T ECHNICAL INFORMATION

- Subject** ▶ Changes of Bateery Box and Charger Case Set
- For Models** ▶ DC1410, DC1412, LG123
- Country** ▶ All countries
- Description** ▶ As illustrsted below, Battery Box and Charger Case Set have been changed to those of DC1411.
The new parts have five spots to accept the terminal while the current having four.

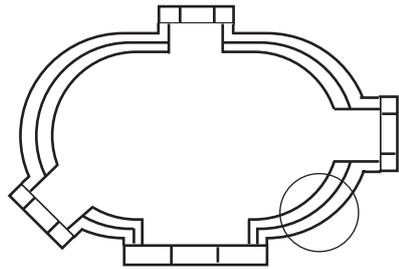
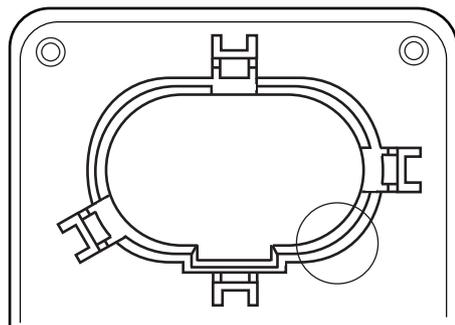
▶ Current	▶ New
<p>Battery Box</p> 	 <p>(Part No.415950-0)</p>	 <p>Fifth spot to accept a terminal has been added to the encircled area of the current part.</p> <p>(Part No.416467-6)</p>
<p>Charger Case Set</p> 	 <p>(Part No.182861-1 for DC1410, DC1412) (Part No.182933-2 for LG123)</p>	 <p>Fifth spot to accept a terminal has been added to the encircled area of the current part.</p> <p>(Part No.182967-5 for DC1410, DC1412, LG123)</p>

Battery Box and Charger Case Set are interchangeable as a set.
